## Pre-Application Meeting PRE 23-11 Agenda

Wednesday, May 17, 2023 at 11:00 a.m.

Thank you for joining staff for pre-application meeting PRE 23-11 to discuss a proposed gas station, convenience store, and car wash at 2115 Molalla Road NE covering Tax Lots 051W09B001000, 1100, & 1200 (primary lot) and located between Woodburn Place and Woodburn Place West Apartments. The subject property is approximately 0.93 acres and within the Commercial General (CG) zoning district following annexation ANX 22-04 via Ordinance No. 2607 adopted April 24, 2023. Section references are to the [Woodburn Development Ordinance \(WDO\)](#).

*Figure 3.01B – Major Arterial*

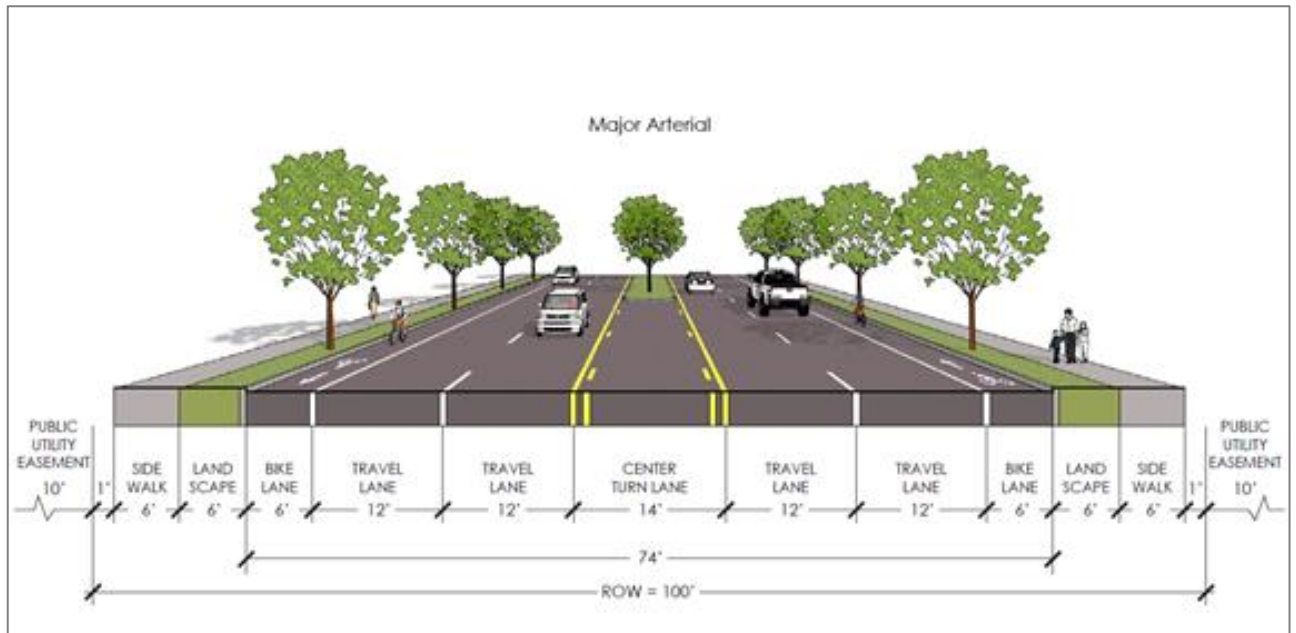
- Right-of-way (ROW): Dedicate variable width ROW to achieve 50 ft width from centerline.
- Streetside public utility easement (PUE): Grant a streetside PUE (10 ft min width per the figure, and 8 ft max per 3.02.01F.2).
- Improvements: Construct half-street improvements along the frontage to match Figure 3.01B.
- Transit: Upon application, staff would consult with the Assistant City Administrator and Transit Manager to determine if a transit shelter would be located in front of this development. Potential CU conditioning might be for installation of a City-spec bus stop shelter or payment of fee in-lieu (being set likely at around \$14,000).

The updated site plan showing the addition of 2540 Newberg Hwy and a proposed diner space.

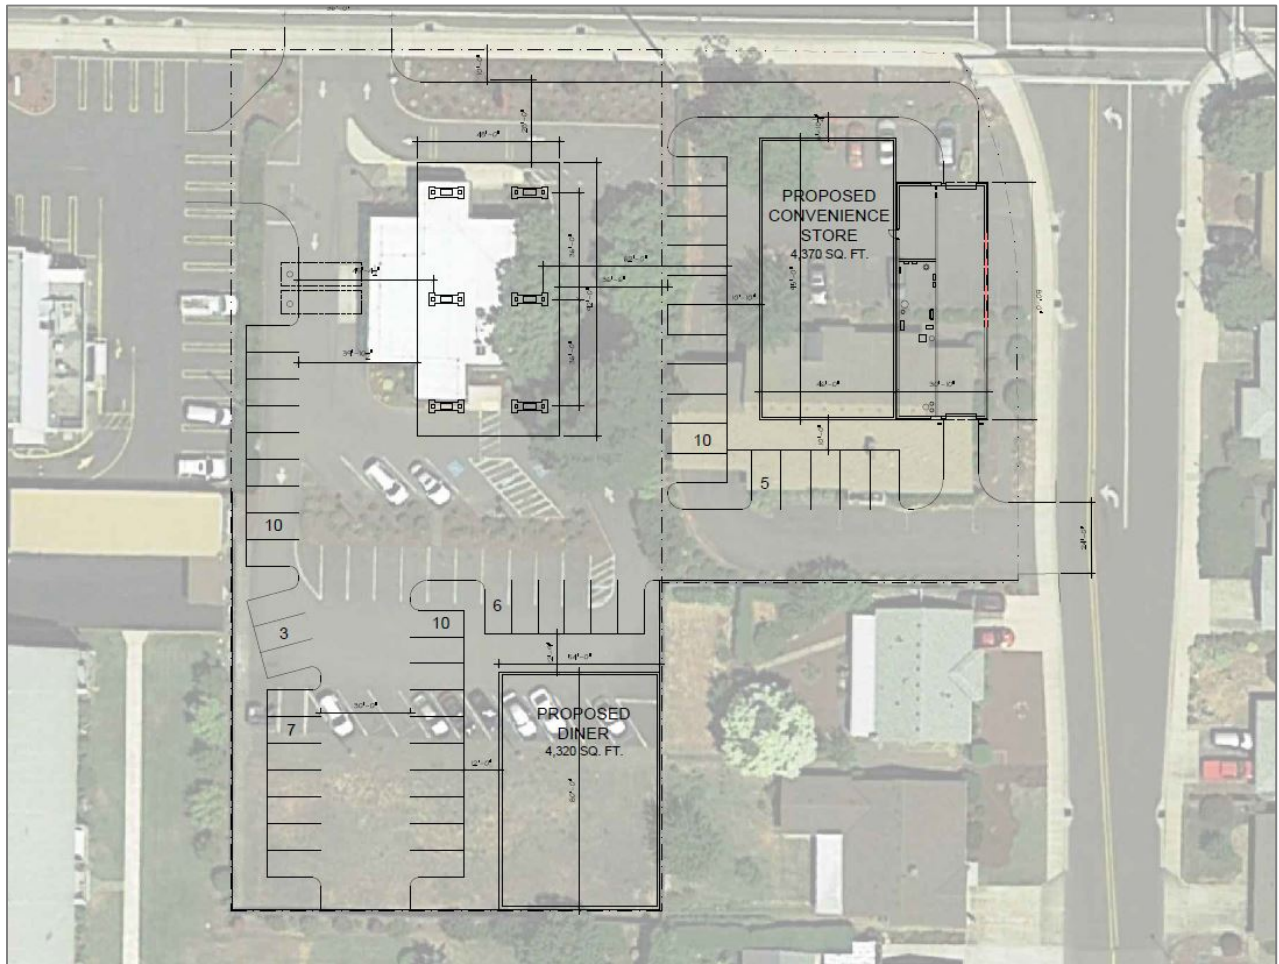
The basic discussion items that come with the expanded site redevelopment area are:

- Frontage/public/street improvements: Given additional length of frontage that would include both highway and a street, is the applicant preparing for the required upgrades to frontage/public/street improvements?
- Site plan layout: Placing active uses (diner and convenience store in that order) at and along frontage, and placing the car wash and gas pumps away. The diner should be at the corner of the highway and street.
- Off-street parking: Adjacent properties being developed in a manner that shares parking facilities are eligible for a shared parking allowance to contribute to total parking requirements.

The turn lane from Oregon Way west onto Newberg Hwy. It is designed to accommodate large trucks.

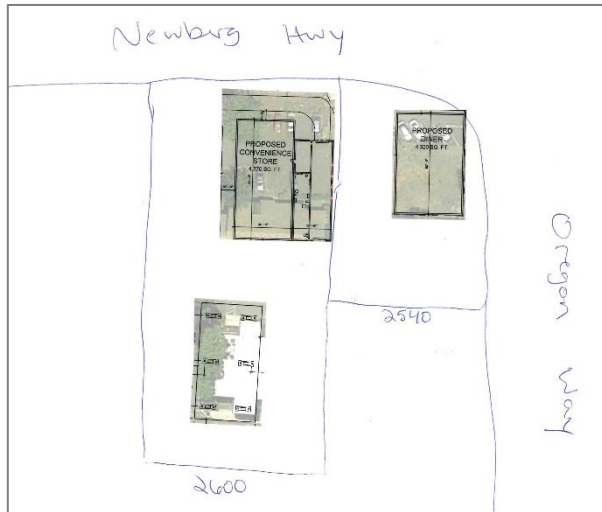
Yet, Oregon Way is signed to prohibit large trucks.

**PRELIMINARY SITE PLAN  
 2115 MOLALLA RD NE  
 WOODBURN, OR**

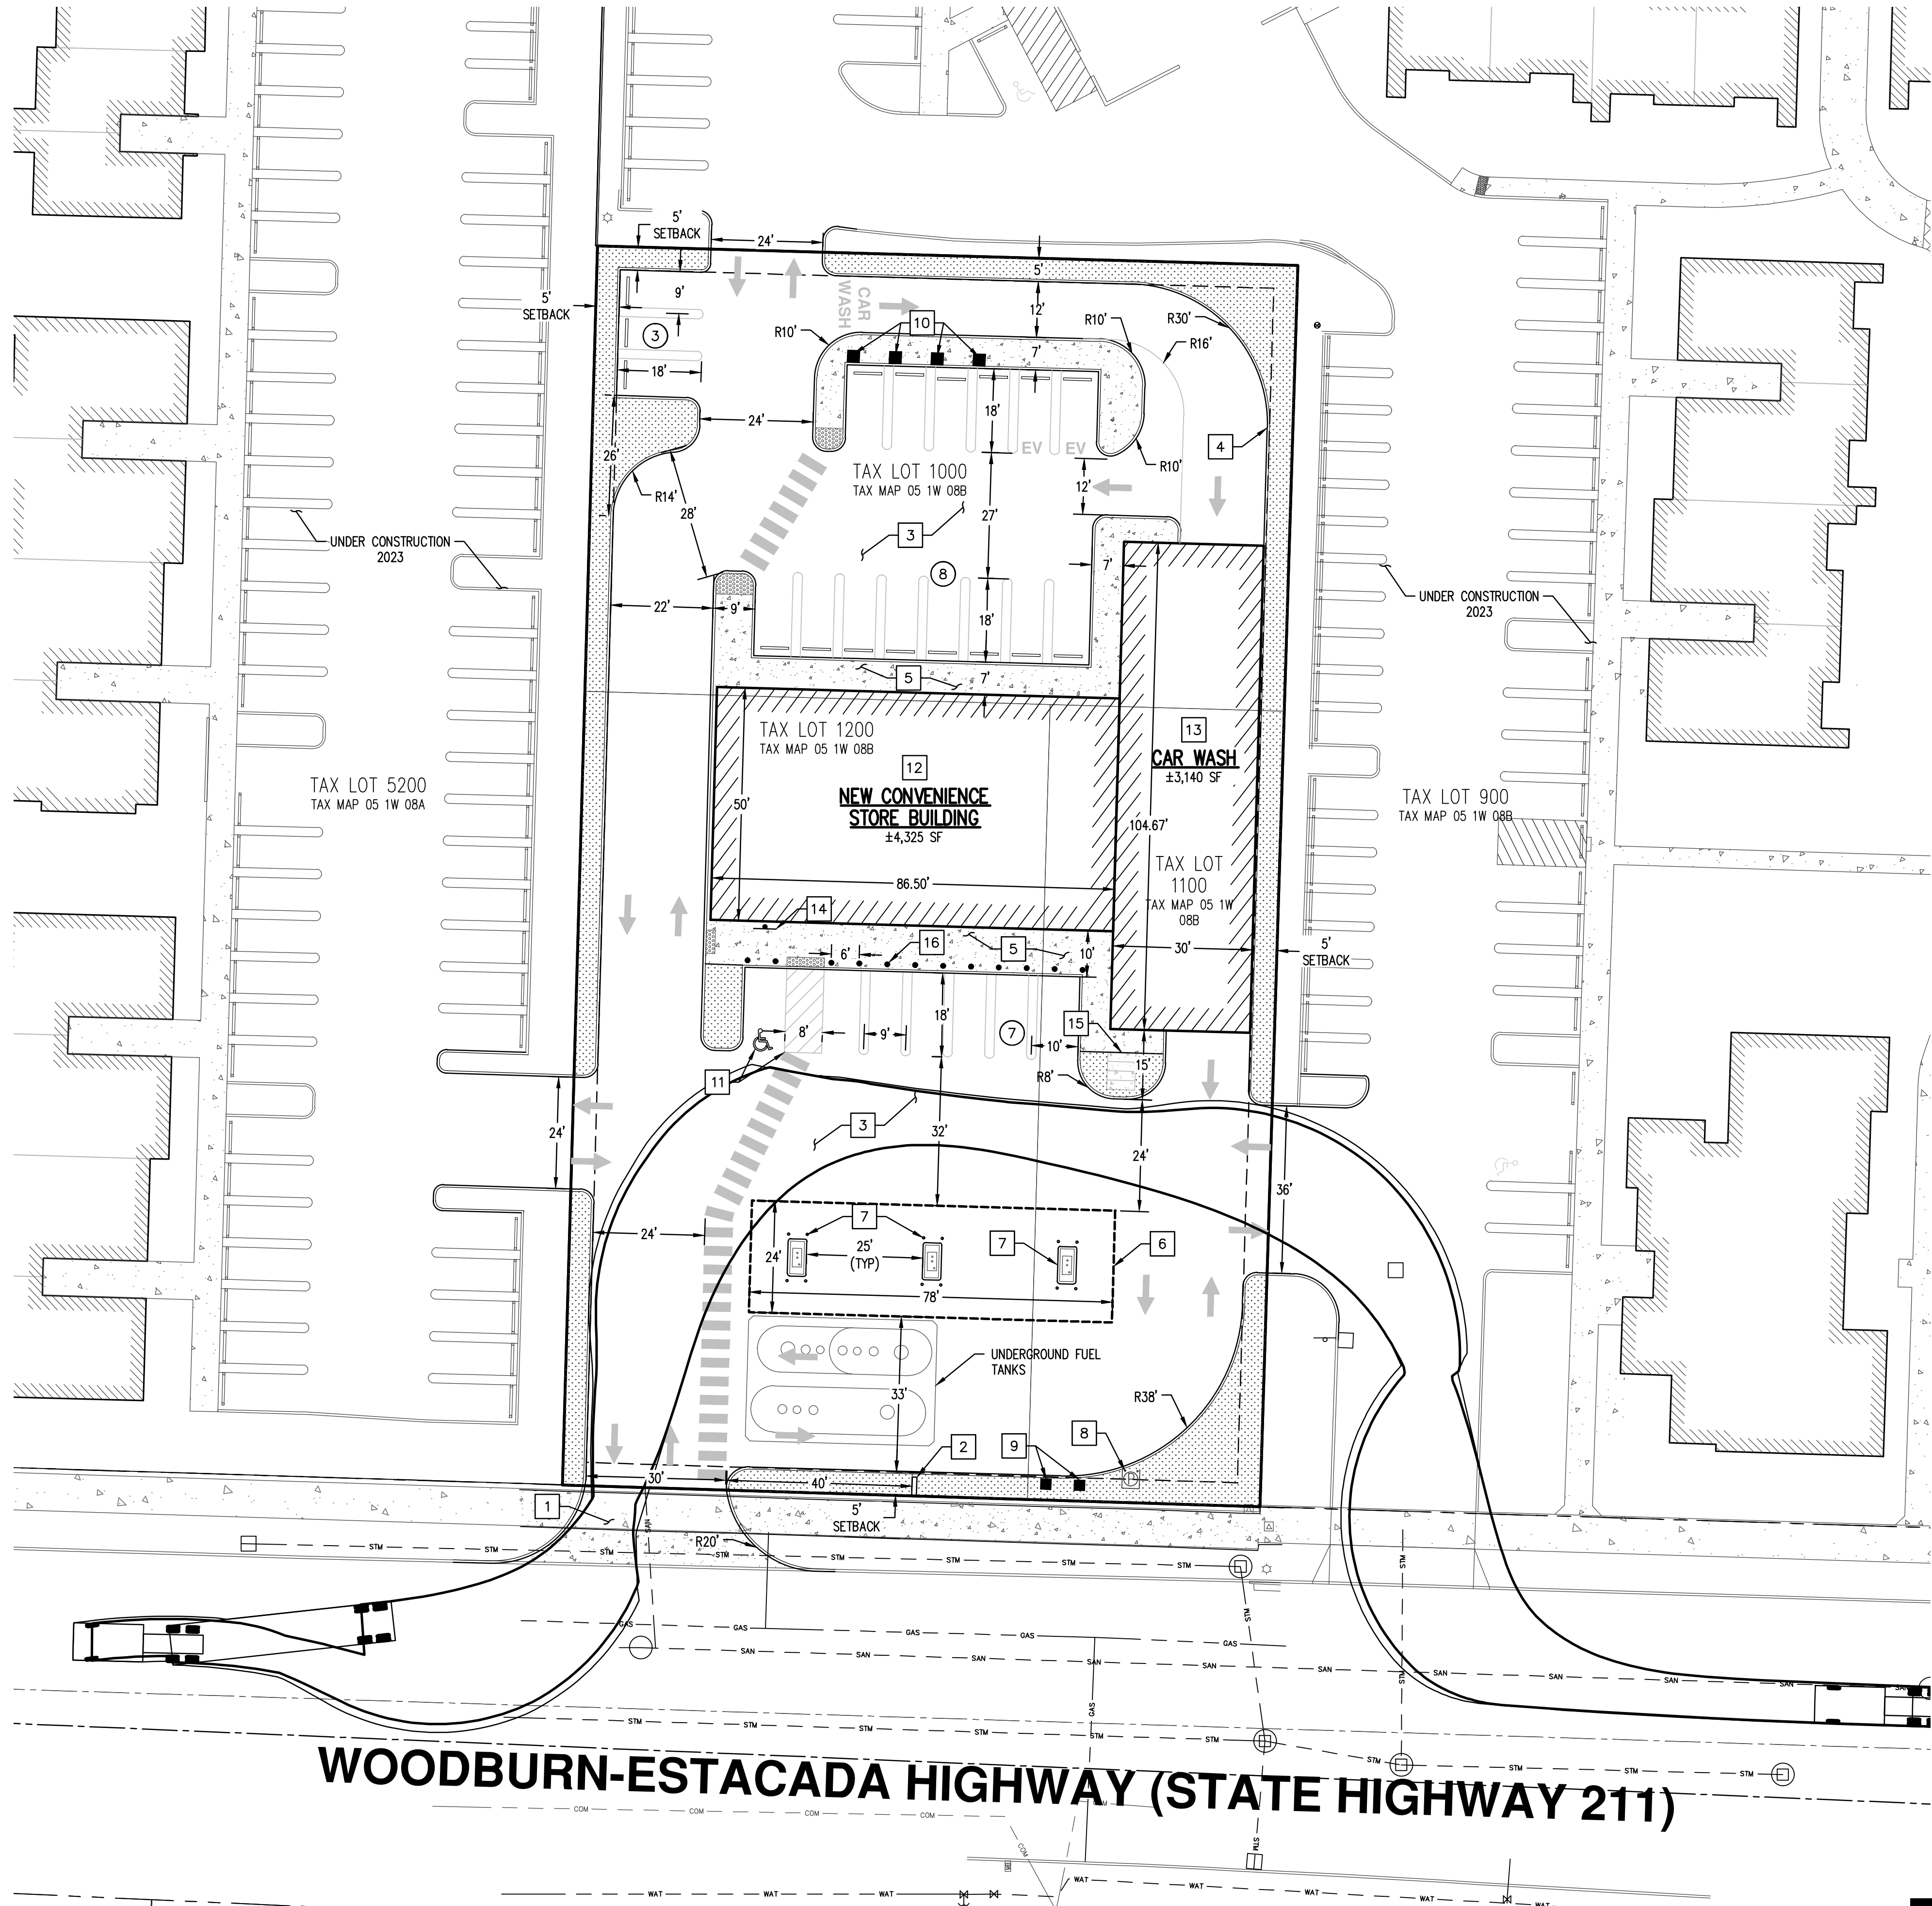
- a. Cross access drive aisles exceed minimum; but, reduce off-street parking by removing stalls from both Woodburn Place and Woodburn Place West Apartments, likely creating non-conformities. The simple standard is a minimum is 2 stalls per apartment, and both apartment complexes barely met the minimum.

- b. The driveway at 30 ft wide between faces of curb might exceed the commercial max width per WDO Table 3.04A of either 24 ft or, if a left turn pocket is added, 36 ft. The striped arrows indicate no left turn pocket. 30 ft would be acceptable if having two 10-ft lanes and a 10-ft left turn pocket. Otherwise, narrow to 24 ft.

- c. Landscaping: Though the minimum parking setback is 5 ft, because the minimum streetside public utility easement (PUE) per WDO Figure. 3.01B "Major Arterial" is 10 ft, and Public Works doesn't want newly planted streets in PUEs, expect a CU condition requiring a deeper parking setback to fit planting of front yard trees, a depth in the range of 13-15 ft.

- d. Make the west cross access (via Woodburn Place West) one-way east, drive aisle width min 10 ft per the WDO, max 12 ft through CU.
- e. Regarding east cross access, narrow to the drive aisle min width of 24 ft per Table 3.05B. To accommodate fuel truck turning radius, beyond each end of the 24 ft construct mountable curbing the same width as the adjacent landscaped peninsulas.

- f. Where's carpool/vanpool (C/V) parking per Table 3.05C?

Walkway and wide walkway conformance with 3.04.06 is missing. The proposed walkway as striping-only and ends within the driveway approach / apron / curb cut / ramp in the inbound traffic lane.

It doesn't. See Table 3.05A, row 6. Staff would assume the whole 4,325 square footage of convenience store for calculating, "1/ 200 retail area + 3/ service bay + 1/ pump island". The development would require  $4,325 / 200 = 21.6$  stalls, plus 3 pump islands  $\times 1 = 3$  stalls, totaling 24.6  $\rightarrow$  25 stalls. The proposed 24 would fail to meet the min 25.

Regarding bicycle parking, the symbol and Note 15 are too vague to determine conformance with Table 3.05D and 3.05.06; however, having seen 4 stalls total mentioned in pre-app narrative question 24, this would likely satisfy the WDO and whatever a CU condition would require.

Staff doesn't see them on the draft site plan. See not only Table 3.05E but also the standards beneath the table in 3.05.03I.
